4.1 **COR 32-2023 Flats Conceptual Designs for Public Engagement**

To:	Chair Stratthdee and Members of Strategic Priorities Committee
Prepared by:	André Morin, Director of Corporate Services / Treasurer
Date of Meeting:	18 April 2023
Subject:	COR 32-2023 Flats Conceptual Designs for Public Engagement

**Re: Draft Concept Plans for Milt Dunnell Field
1 Veterans Circle, Town of St. Marys**

DRAWING:
CONCEPT A

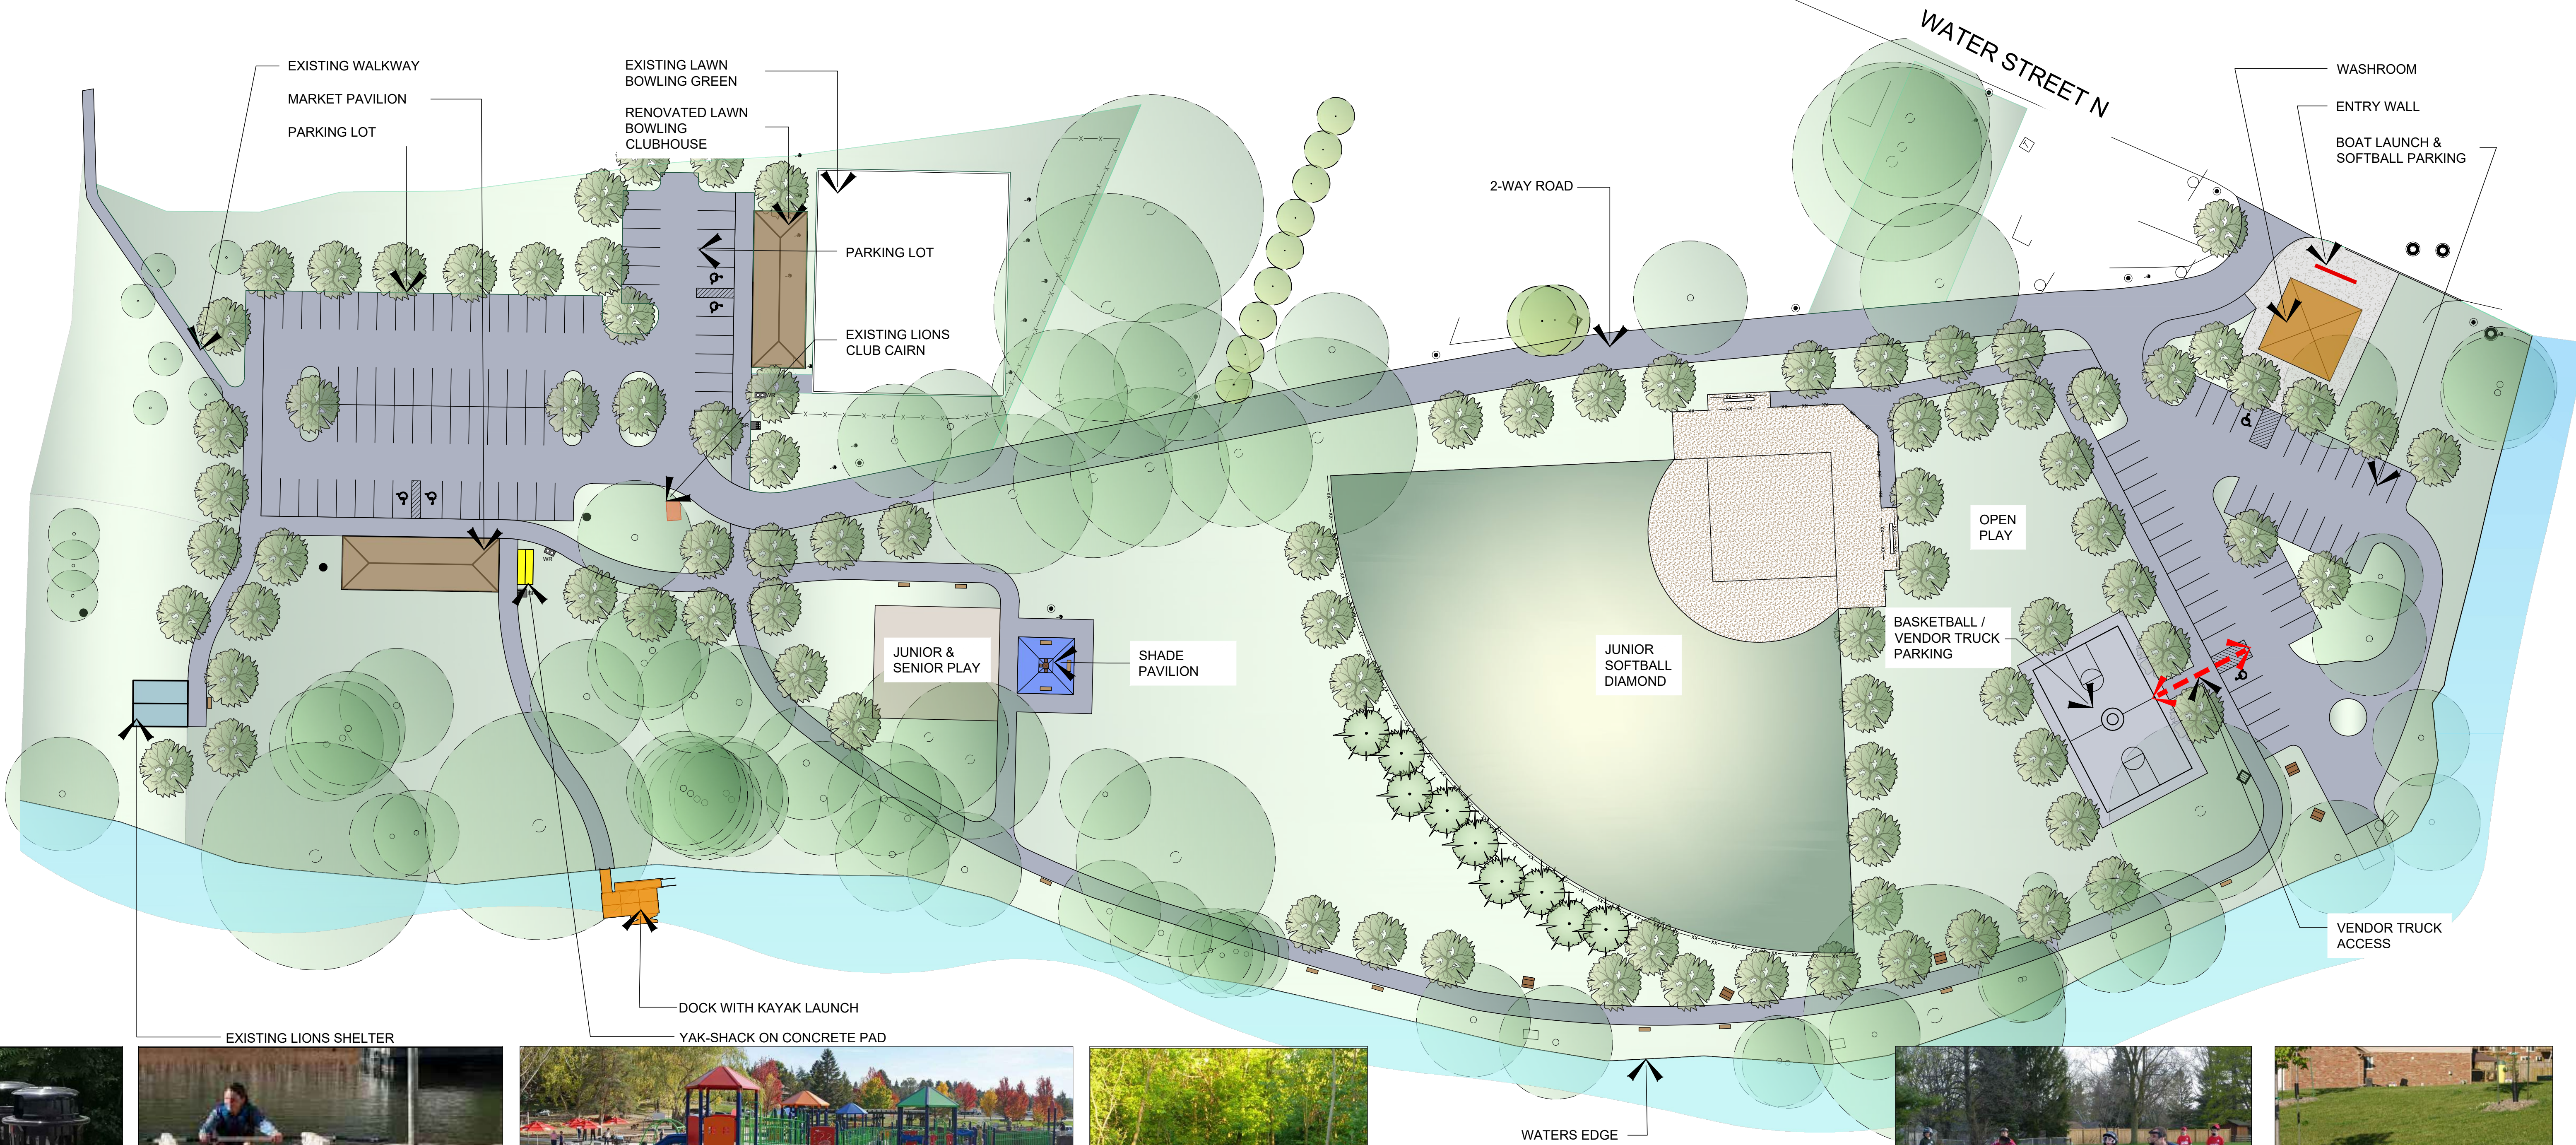
- At a staff level we have no objection to the currently proposed replacement concepts and footprint sizes for Buildings A-E (Lawn Bowling Facility, Storage Building, Lion Pavilion, Shed 1, and Shed 2). We would recommend Option B for the location of the replacement Storage Building given elevation data for the park suggests it would be easier to flood proof at the more easterly location;

- Provided all proposed structures are open walled (as per the submitted concept photos) and set a minimum of 30 metres back from the top of bank of the North Thames River and Trout Creek, we have no objection to either the currently proposed band shell concept or the currently proposed shade pavilion concept;

- It is unknown at this time if the proposed washroom could be supported. In general, our policies would not support a new building of this size or use in an area as flood susceptible as The Flats. We also generally require new park washrooms be located outside the flood hazard. However, we acknowledge there is no room outside the flood hazard at this park and further acknowledge this is a municipal structure with considerable public benefit. On limited occasions (only 2 times in the last 20 years) we have approved new municipal park washroom facilities in flood hazard land but with strict conditions. They must be designed (by a qualified professional) to be completely flood proofed to the level of the Regulatory Flood. This would require elevating the entire facility above the Regulatory Flood elevation which may prove challenging at this site. The

- UTRCA has no objection to either of the currently proposed playground size or locations;
- We note at other municipal park locations in our watershed gravel surfaces tend to wash away into the river during a flood which results in increased maintenance time/cost for municipal parks staff and the import of fresh gravel. Rather than gravel surface for a playground at this location we recommend the playground surface be designed with a base that is less likely to wash away. For instance some of the newer (and safer) playground options such as pour-in-place rubber;
- All playground structures should be designed to be firmly anchored into the ground so as not to detach in a Regulatory Flood Event. Depending on the size and specifics of the playground structure proposed, we may require that a qualified professional confirm how the structures would be anchored properly;

- Provided grading will be minimal and no external fill will be required to construct the sports fields then the UTRCA has no objection to either the proposed soccer field or the proposed baseball diamond;
- At this site-specific park we would recommend the soccer field over the ball diamond given the same concerns with the gravel surface washing away as noted in the playground section above. Further, a grassed soccer field would allow for better (and faster) infiltration of water after a precipitation event or flood;

riverine flooding. This area of the North Thames River meets none of those qualifiers. As previously mentioned, we are not supportive of docks in areas of running water that are highly susceptible to flooding given the increased likelihood of the structure detaching. UTRCA staff has seen numerous docks (of all sizes) detach over the years and float downstream where they damage bridges or other private properties. Many become blockages which then further back up floodwaters onto the properties where they lodge at.

- This area is deemed high risk floodway and would be susceptible to high flood flow velocities and higher flood depths for not only the 1:250 year flood but other smaller seasonal events. Staff has documented many events within the past 20 years (as mentioned above) that would be cause for concern.
- Rather than a traditional riverbank dock, we recommend the Town consider a novel approach – the excavation of a small side channel, where access can be attained to an accessible dock structure. This would safely accommodate accessibility needs for kayaks/canoes to safely enter the water in the park and then exit via kayak/canoe to the connected river. Our staff would be more than happy to assist the Town with design options that would negate the need for an external “dock” structure;

- UTRCA staff would like to keep the addition of paved surfaces to a minimum as policies would require maintenance of the stage-storage-discharge relationship for a range of rainfall events;
- While we disagree with the calculations of the asphalt, concrete and hardened structures provided, the greater challenge is the increase in size and/or configuration of hardened areas in certain locations which will change the way floodwaters (and erosion forces) behave on the site.

In general, UTRCA policies would not support a new parking lot and increased parking areas of this size in an area as flood susceptible as the Flats. While we acknowledge the existing ring road may be narrowed along the river in the conversion to a trail, the new parking lot proposed for the south of the site may impact the stability of the Trout Creek retaining wall and increase localized flooding and/or erosion. As mentioned on site, we recognize the need to pave some parking and sidewalk areas in relation to replacement buildings to comply with accessibility standards.

DRAWING:
CONCEPT B

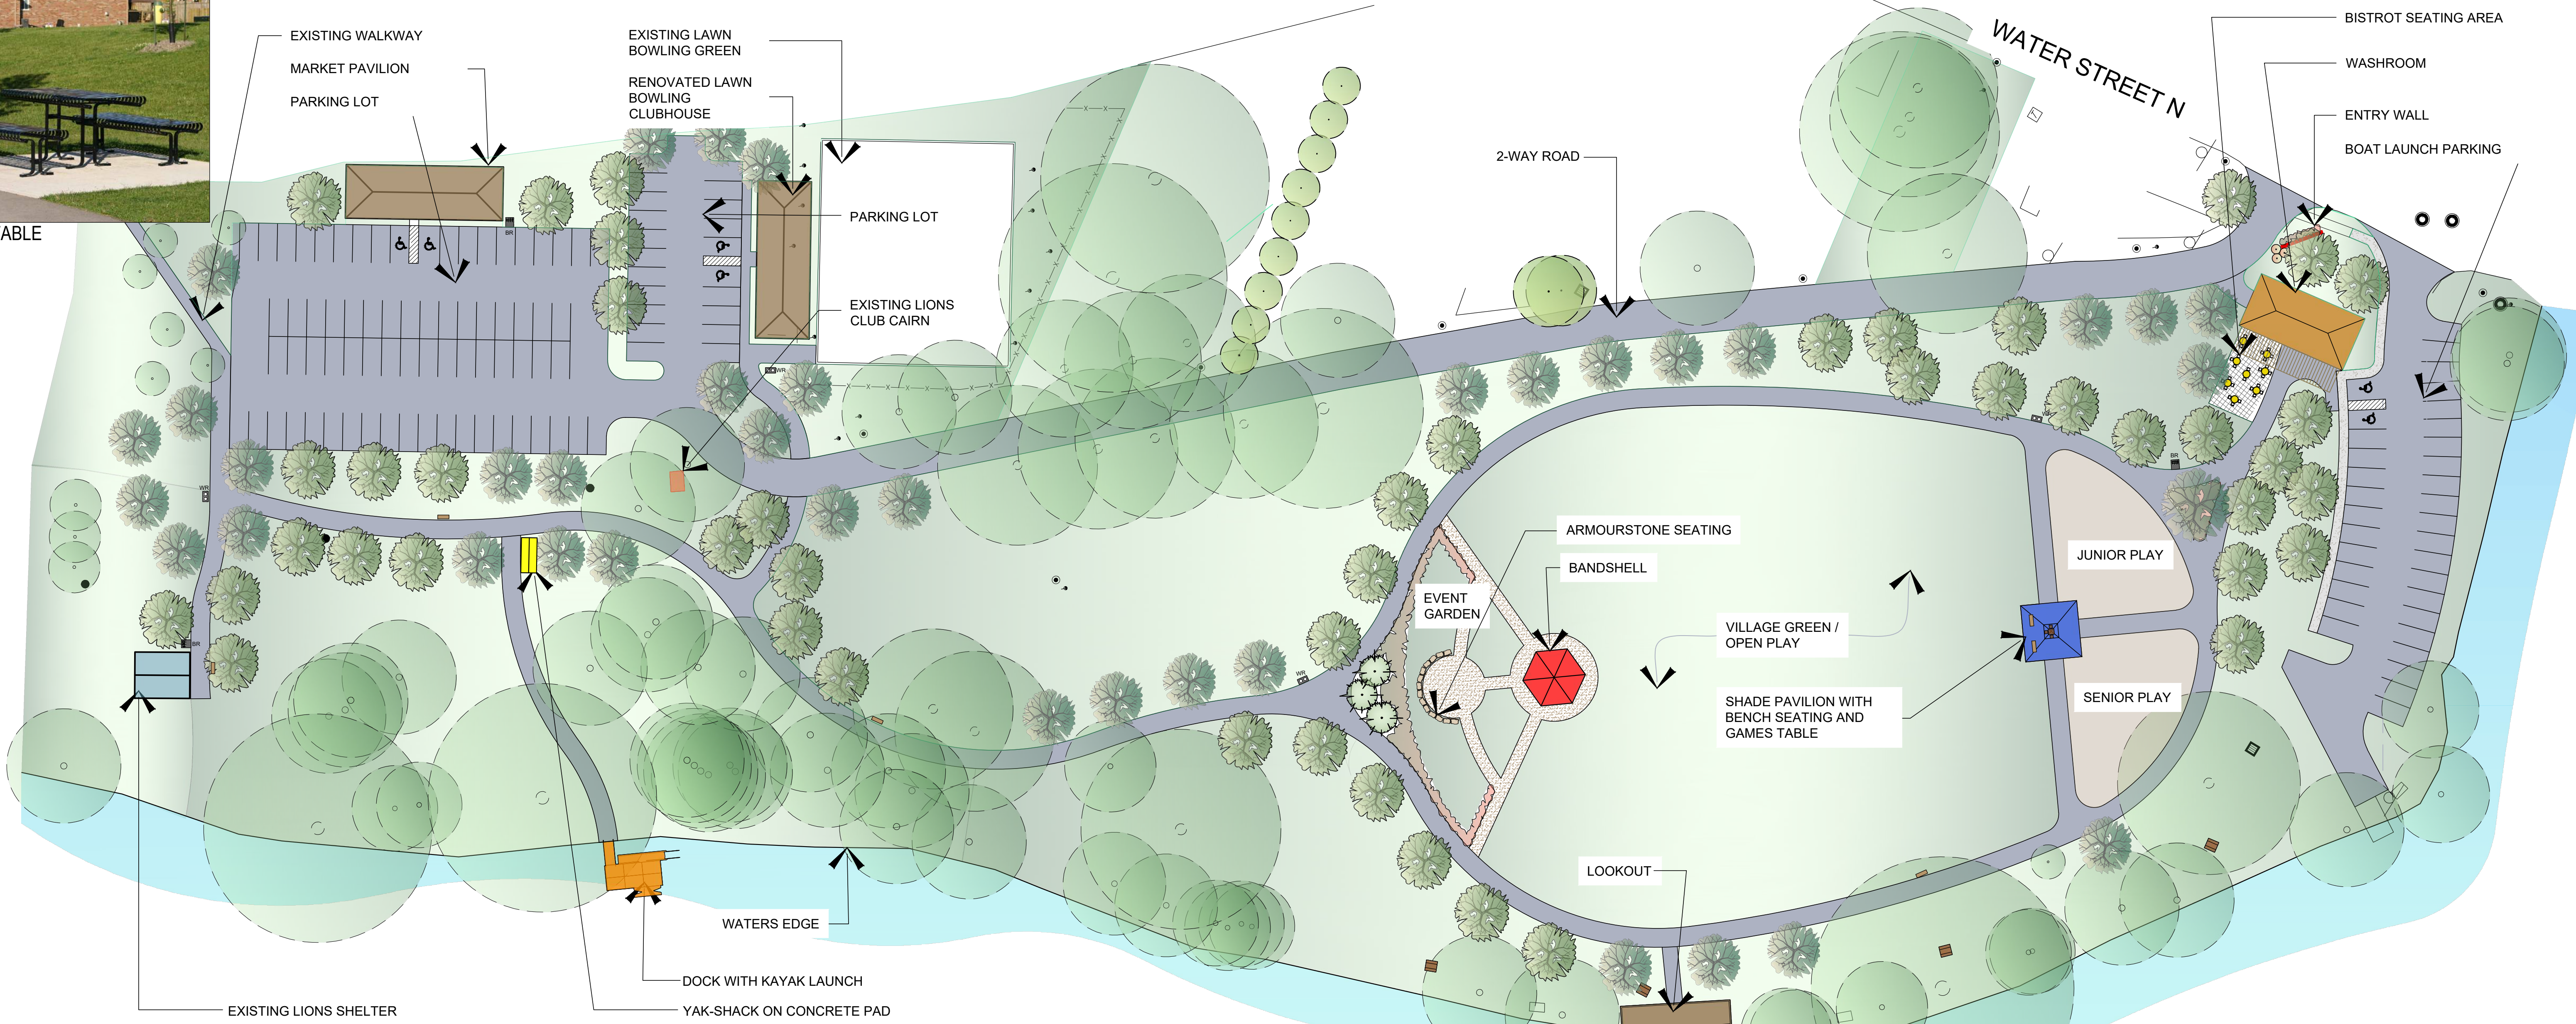
- The Authority is highly supportive of strategic look-out points that would guide park visitors to select locations along the trail and limit foot traffic in other bank areas to be naturalized. However, we discourage the type of look-out structure proposed in the submitted photos for the same reasons as the dock structure noted above. UTRCA bio-engineer staff have designed other trail look-out points (for other municipalities along parts of large creeks or the river) that serve as erosion control, trail focal points and include improved aquatic or riparian habitat. Our staff would be more than happy to assist the Town with design options that would be more suitable for a flood susceptible river bank location;

- Gardens are perfectly suited for this location and we are supportive. Given the location immediately adjacent Trout Creek and the North Thames River, we recommend native plants and discourage invasive plants as the seeds may travel via air or the waterways to invade and spread on downstream properties;
